Tree Constraint Plan

68 Oxford Road, Dewsbury, WF13 4EH

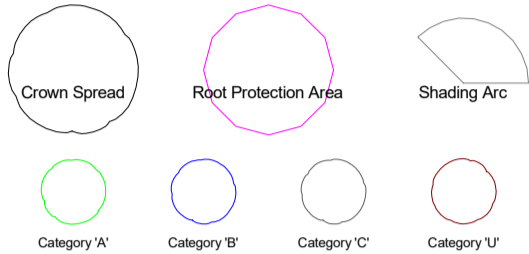
Modified RPA T014

The TCP clearly shows the full RPA of T014 located 200–300mm lower than the application site, on the adjacent ground level.

This level change means the RPA does not extend horizontally into the proposed footprint in the way assumed by the consultee.

The amended TCP submitted with the application accurately reflects the modified RPA geometry, taking account of the lower adjacent ground level and the natural containment of rooting by the boundary structure.

The proposed development therefore does not encroach into the functional rooting area of T014.

Any minor canopy adjustments required can be undertaken in accordance with BS3998, and willow species are highly tolerant of cyclical pruning.
